Homelite®

BULLETIN

NO. H98A-007

SUBJECT: ELECTRIC START TRIMMER

Figure 1

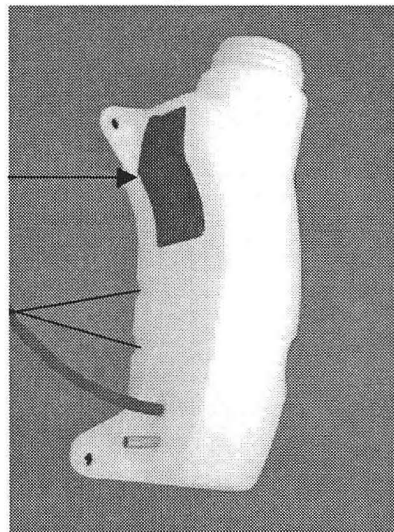
Under extreme operating conditions it is possible for the fuel tank to expand and contact the engine shroud. Continued operation with this condition could result in a fuel leak developing at the point of contact.

The fuel tank has been modified with two reinforcing ribs to prevent the expansion. A foil reflective tape has also been added to reduce the heat conductivity of the tank and lower the overall operating temperature. See Figure 1.

All affected units should be updated to the new tank configuration. All customers should be contacted for repair of affected blowers in their possession. The enclosed notices should be posted at your service counter to alert customers of the situation.

New Tank
Part Number UP00495
